## **Generic Design Assessment – New Civil Reactor Build**

### **GDA Close-out for the EDF and AREVA UK EPR™ Reactor**

- GDA Issue GI-UKEPR-SI-02 Revision 1**
- Structural Integrity – RPV Surveillance Scheme**

Assessment Report: ONR-GDA-AR-12-014  
Revision 0  
September 2012

Schematic section through the heavy reflector, core barrel and RPV wall

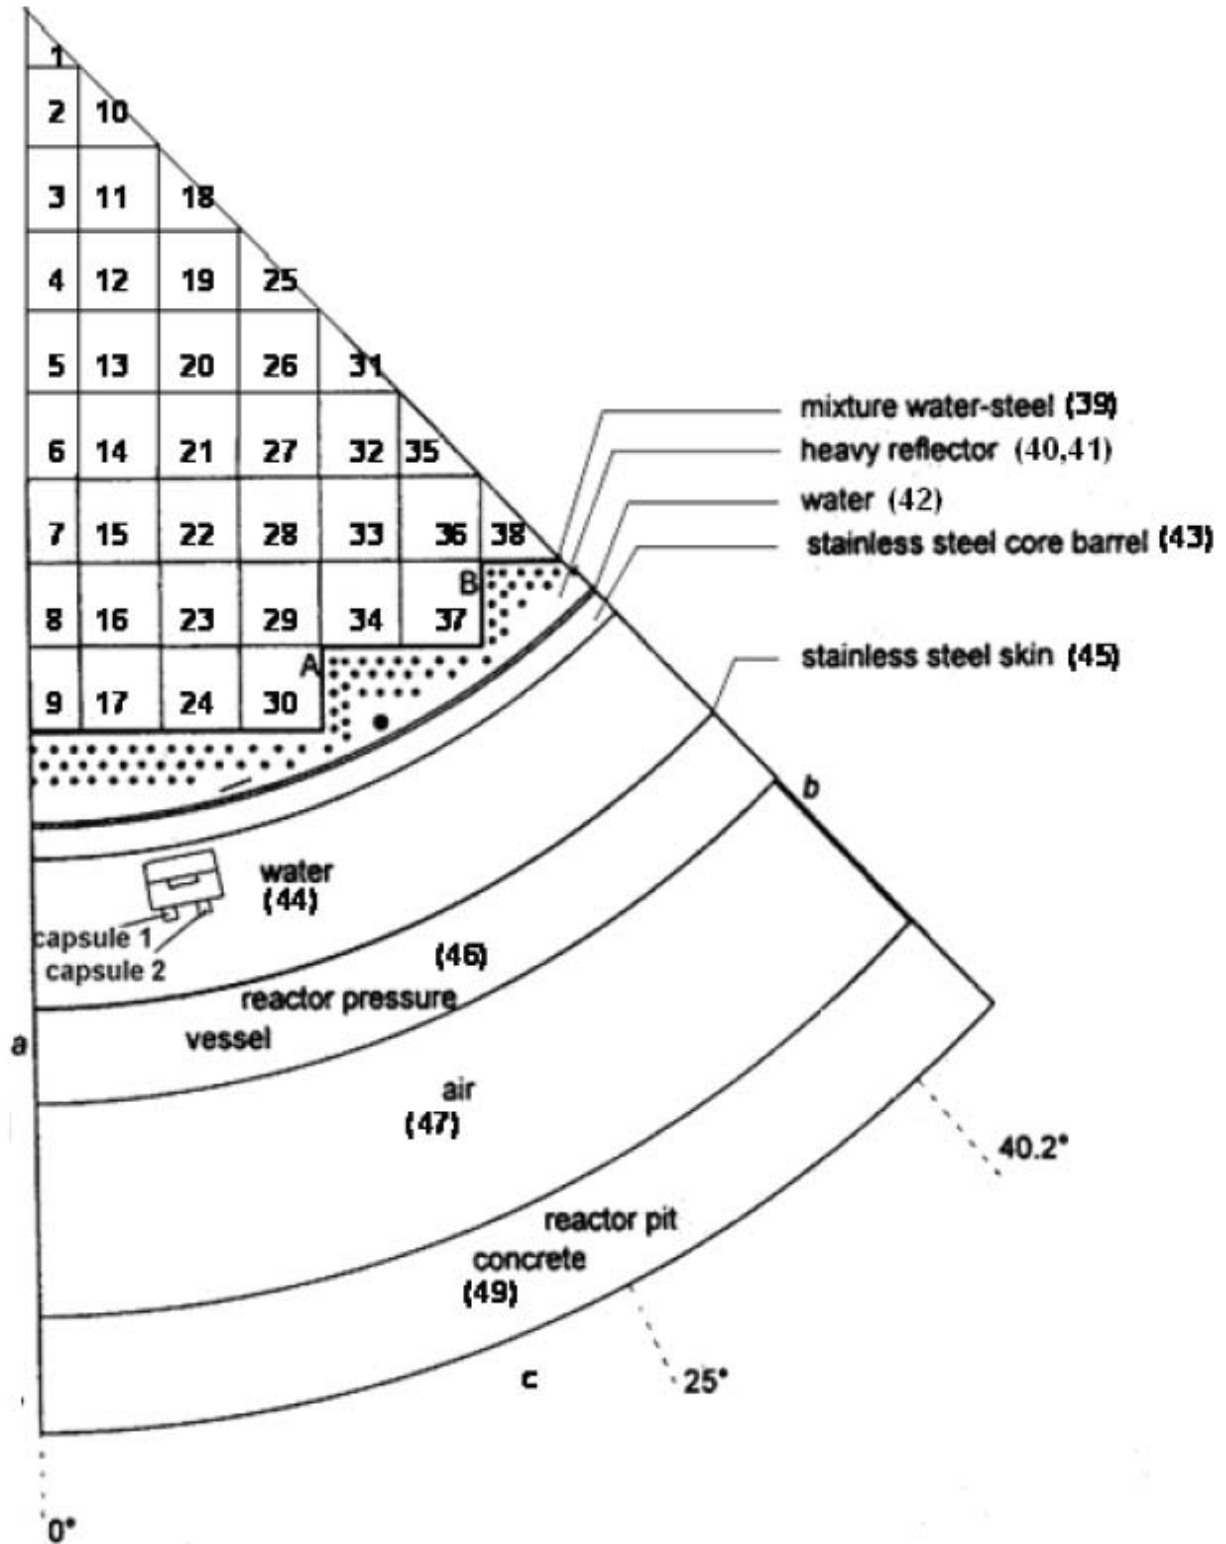
- 29 The surveillance specimens used to monitor progress of embrittlement in the EPR™ are placed close to the heavy reflector, whereas there is a significant water gap between the reflector and the RPV wall which reduces the proportion of lower energy neutrons at the RPV wall. As a result the EPR™ neutron spectrum is quite different from a standard PWR at the location of the surveillance capsules, but the effect is much less pronounced at the RPV wall where the spectrum is similar to a standard PWR. Consequently the empirical correlation used to relate damage in the surveillance specimens to damage in the RPV wall, which has been derived using data from standard PWRs, is not directly applicable to the EPR™.

- 30 The figure below which is taken from Ref. 15 illustrates the arrangement of the heavy reflector, core barrel and RPV wall as well as the surveillance capsules and water gaps.
